# DEVELOPMENT SERVICES

## SITE PLAN REVIEW AND APPEARANCE BOARD

238 SE 1<sup>st</sup> Ave – Exterior Renovations

Meeting	File No.	Application Type
December 11, 2024	2024-148-SPR LV1	Level 1 Site Plan Modification with Landscape Waivers
Property Owner		Authorized Agent
Wylie Properties LLC		Sandra Miura

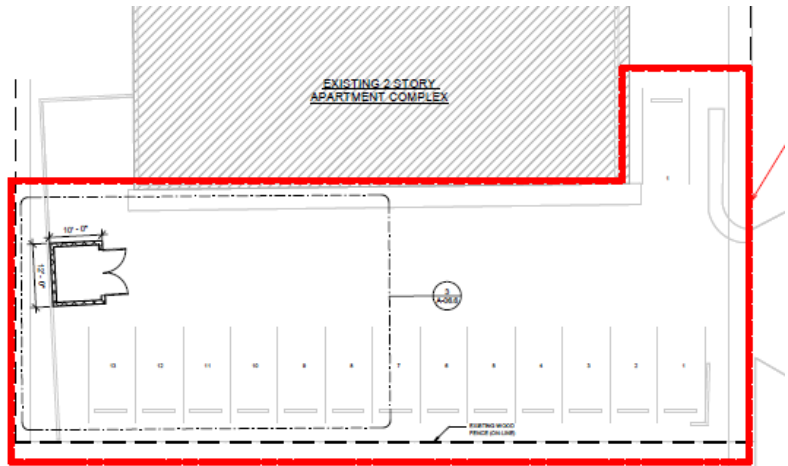
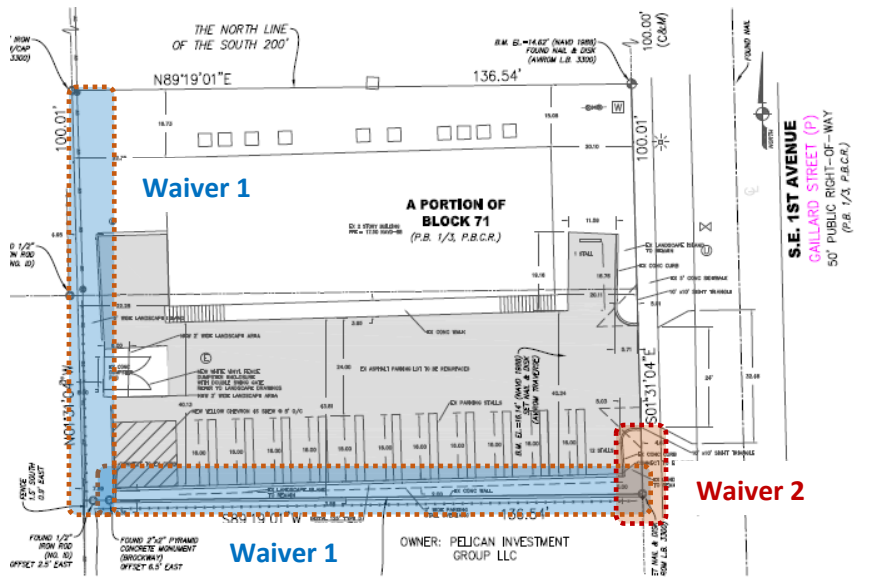
The illustration to the right depicts the proposed exterior color transition from the existing beige to **Chantilly Lace OC-65**, a crisp and clean white shade from Benjamin Moore's collection. This selection is intended to modernize the building's appearance, providing a fresh, neutral aesthetic that complements its surroundings while enhancing its curb appeal.

Additionally, the proposed **new wood fence** will be painted in a classic **white** finish. The choice of white for the fence aligns with the updated building color, creating a cohesive and harmonious look. The white paint will highlight the natural grain of the wood while providing a durable and polished finish suitable for outdoor exposure.

**LDR Section 4.6.16(H)(3)(d) - Waiver 1**

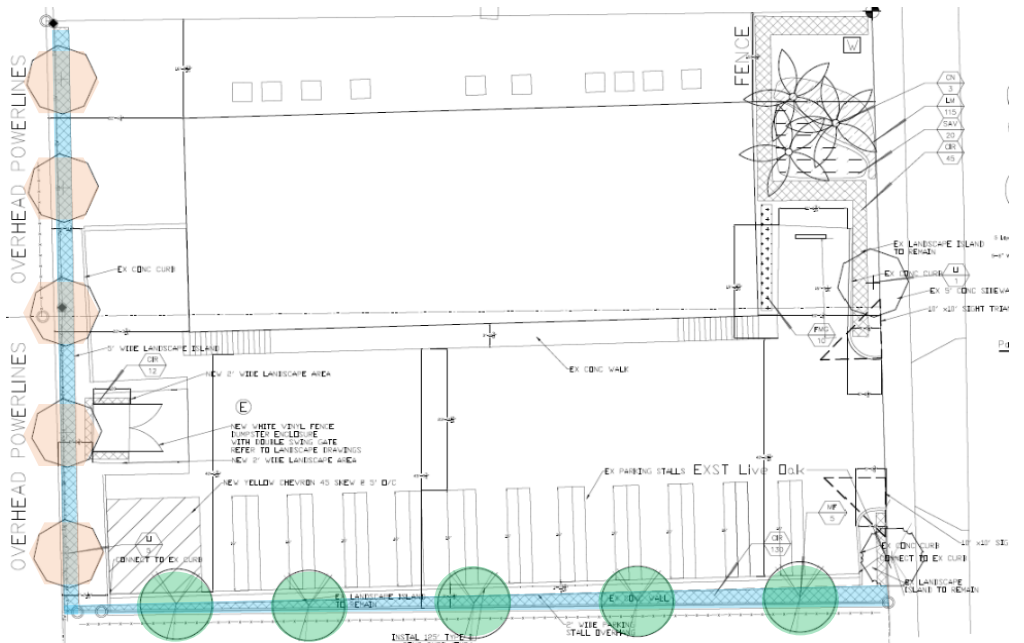
The applicant seeks relief from Section 4.6.16(H)(3)(d) of the Land Development Regulations (LDR), which requires a landscaped barrier with a minimum width of five feet to separate off-street parking areas or vehicular use areas from abutting properties. The landscape barrier must provide a continuous screen, measuring between three and six feet in height at maturity, within a planting strip that is free from vehicular encroachment, including car overhangs.

The subject site presents physical constraints that challenge compliance with these requirements. Along the **southern property boundary**, the existing landscaped buffer varies in width, measuring approximately 4.3 feet at its widest point on the eastern side and narrowing to 2.3 feet at its westernmost extent. Along the **western property boundary**, the landscape barrier width fluctuates between approximately 2 feet and 3 feet. These existing non-conformities are primarily due to the building's offset placement, the configuration of existing parking areas, and the location of the dumpster enclosure, all of which limit the available space to establish a uniform five-foot-wide buffer.

Additional constraints are present along the **western property boundary**, where overhead utility lines restrict the feasibility of installing taller vegetation that could provide the required vertical screening. These physical and spatial limitations necessitate a tailored approach to achieving the screening objectives of the LDR while accommodating the existing site conditions.

- **Southern Boundary:** The applicant proposes the installation of five **Simpson Stopper trees** (*Myrcianthes fragrans*), which are characterized by compact growth and dense foliage. These trees will be planted at a height of 16 feet, with a six-foot straight trunk and an eight-foot canopy spread, providing vertical screening along this boundary. Additionally, 130 **Red Tip Cocoplum shrubs** (*Chrysobalanus icaco*) will be installed to create a dense hedge at a height of three feet, ensuring continuous visual and functional screening along the southern property line.

- **Western Boundary:** Given the overhead utility lines, the applicant proposes planting five **Crape Myrtle trees** (*Lagerstroemia indica*), selected for their smaller mature height of 12 feet, to avoid conflicts with utilities while providing vertical screening. The same **Red Tip Cocoplum shrubs** will be used to establish a cohesive hedge along this boundary, similar to the southern boundary.

To address these constraints, the applicant has submitted an enhanced landscape plan designed to meet the intent of the code by improving buffering and visual screening along both boundaries while accommodating the site's limitations.

The proposed landscaping enhancements aim to mitigate the reduced barrier widths by leveraging plant species that are well-suited to the site conditions and capable of achieving the buffering objectives of the LDR.

**LDR Section 4.6.16(H)(3)(i) - Waiver 2**

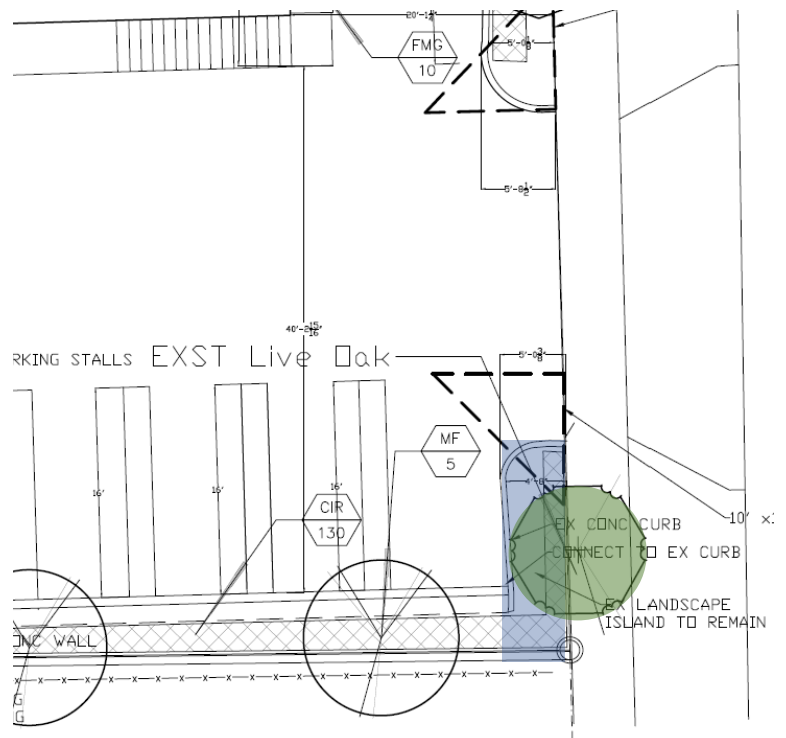
The applicant requests a waiver from Section 4.6.16(H)(3)(i) of the Land Development Regulations (LDR), which requires that landscape islands provide a minimum planting area of 135 square feet, with a minimum width of nine feet (exclusive of the required curb), and be placed at intervals of no more than 13 parking spaces. Each landscape island must include one shade tree and a minimum of 75 square feet of shrubs and groundcover, adhering to specifications outlined in Sections 4.6.16(E)(5) and 4.6.16(E)(6).

The site includes an established landscape island that does not meet the dimensional requirements outlined in the LDR. The existing island is located adjacent to the property boundary abutting SE 1st Avenue and varies in width, measuring approximately **4.21 feet** at its narrowest point on the northern side and **4.26 feet** at its narrowest point on the southern side. Despite the dimensional non-conformity, the landscape island currently supports a **mature Live Oak tree** (*Quercus virginiana*), which fulfills the shade tree requirement and contributes to the site's overall canopy coverage.

The presence of this mature tree presents a site constraint, as modifications to expand the island to meet the minimum width and area requirements would disrupt the root zone and potentially compromise the health and stability of the tree. Additionally, spatial constraints within the existing parking lot configuration further limit the feasibility of achieving compliance without significant structural reconfiguration.

To address these constraints, the applicant proposes retaining the existing landscape island in its current dimensions while enhancing the planting to improve its visual and functional contribution. The plan includes the installation of Red Tip Cocoplum shrubs (*Chrysobalanus icaco*), which will establish a cohesive and consistent hedge along the edge of the island, complementing similar plantings along the southern and western boundaries of the property.

The proposed landscaping enhancement seeks to balance the preservation of the mature Live Oak tree and reflects an effort to prioritize the preservation of an existing mature tree, which provides environmental and aesthetic benefits consistent with the objectives of the LDR. While the proposed solution does not meet the dimensional requirements of Section 4.6.16(H)(3)(i), it aligns with the broader intent of the regulation to enhance the visual and environmental quality of parking areas. The board's assessment should evaluate whether the proposal sufficiently meets the intent of the LDR and ensures consistency with other landscape standards across the site.
